December 9, 2013

Subject: Public Review Draft of California Water Plan Update 2013, Volume 2

FIGURE 1: LOCAL AGENCY BOUNDARIES

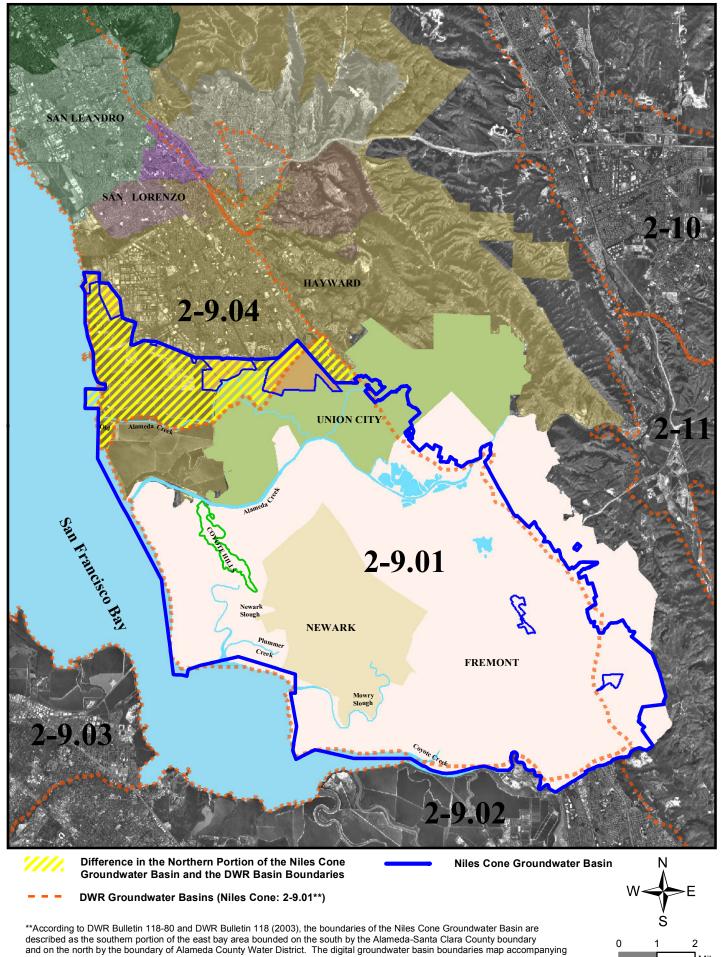
1. Aquifer Description – Alluvial Aquifers, Page SFB-3, Figure SFB-3: This section includes a reference to Figure SFB-3, Alluvial Groundwater Basins and Subbasins within the San Francisco Bay Hydrologic Region. The source of this figure (and Figure SFB-7) is Department of Water Resources' (DWR's) Bulletin 118-2003, which contains significant errors for the northern boundary of the Niles Cone Groundwater Basin (Subbasin Number 2-9.01). As a monitoring entity for the Niles Cone Groundwater Basin in the California Statewide Groundwater Elevation Monitoring Program, ACWD has been in communication with DWR staff regarding Bulletin 118-2003 to correct the northern boundary line (see Figure 1). ACWD requests that this correction also be included in the final California Water Plan Update 2013, Volume 2.

According to DWR Bulletin 118-2013, the Niles Cone Groundwater Basin was established in DWR Bulletin 118-80 as the southern portion of the east bay area and is, "...bounded on the north by the boundary of Alameda County Water District, and the southern portions of the City of Hayward." However, the final digital map version of the Niles Cone Groundwater Basin's northern boundary issued with the report is not in agreement with the text description in DWR Bulletin 118-2003.

The digital map version of the Niles Cone Groundwater Basin boundary does not follow the northern district boundaries per the text description in Bulletin 118-2003 nor does it reflect the original goal of Bulletin 118-80, which was to define groundwater basins in California to facilitate groundwater management purposes, with special attention paid to areas where groundwater basin management had already been initiated (DWR, 1980).

and on the north by the boundary of Alameda County Water District. The digital groundwater basin boundaries map accompanying Bulletin 118 (2003) shown here is inconsistent with the existing basin description, especially in the northwestern corner of the basin. DWR has been notified of the error and will review the data for the next update of Bulletin 118.
